Document No. 020250
PBS&J Job No. 440951

CANYON RESERVOIR WATER QUALITY AND
REGIONAL WASTEWATER PLANNING
STUDY REPORT
COMAL COUNTY, TEXAS

February 2003

FIGURE 4-1

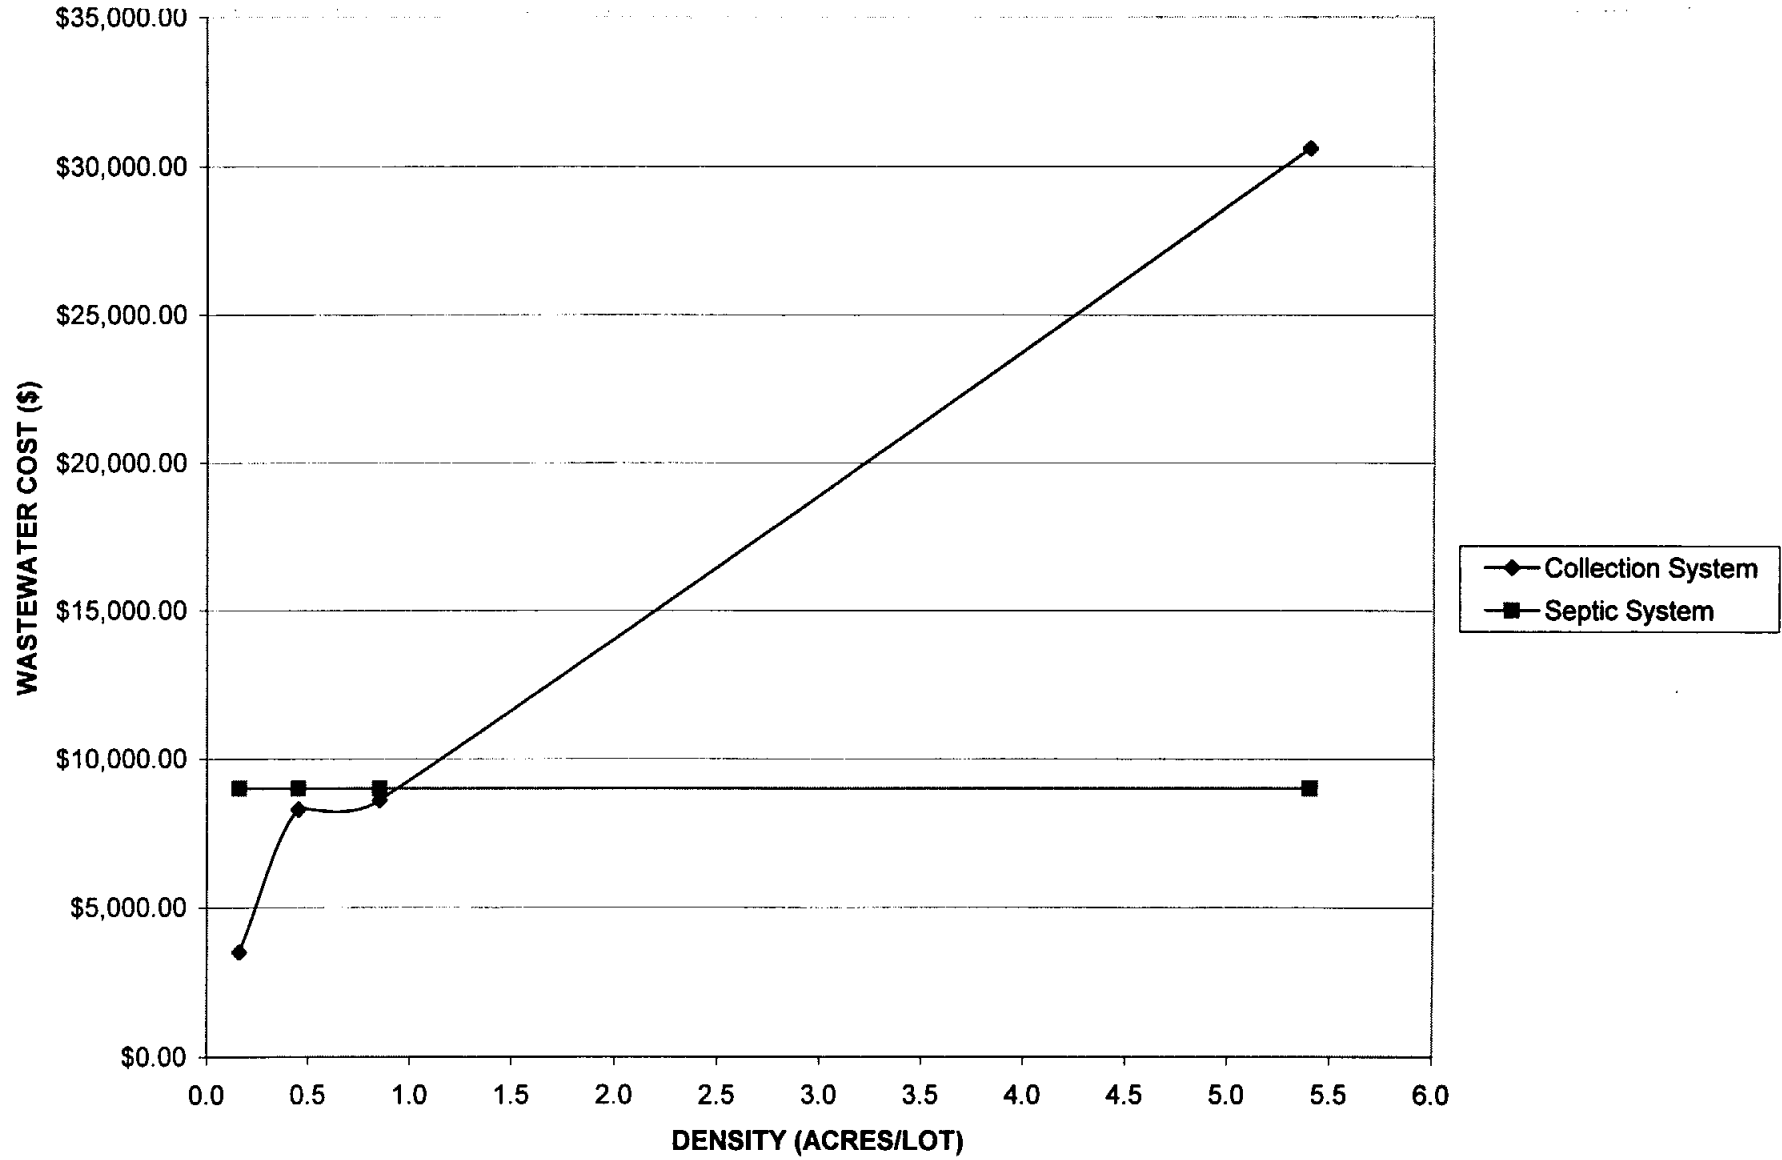
6. Figure 4-1, clarify if wastewater costs shown are per connection.
7. Additional information could have been provided to increase confidence in the results during the treatment of septic system (OSSF) loading. A major assumption concerning impacts of OSSF is the degree to which seepage from drain fields finds its way to Canyon Lake. Additional calculations based on other rates could provide a sensitivity analysis that would be critical to interpretation of the findings.
8. For loadings from OSSF's, another important assumption is the amount of nutrients removed in the drain field. The draft Final Report is based on a 90% removal. Estimates of removal at lower levels have been noted. More information, such as sensitivity analysis would show whether this is an important assumption for the conclusions of the report.
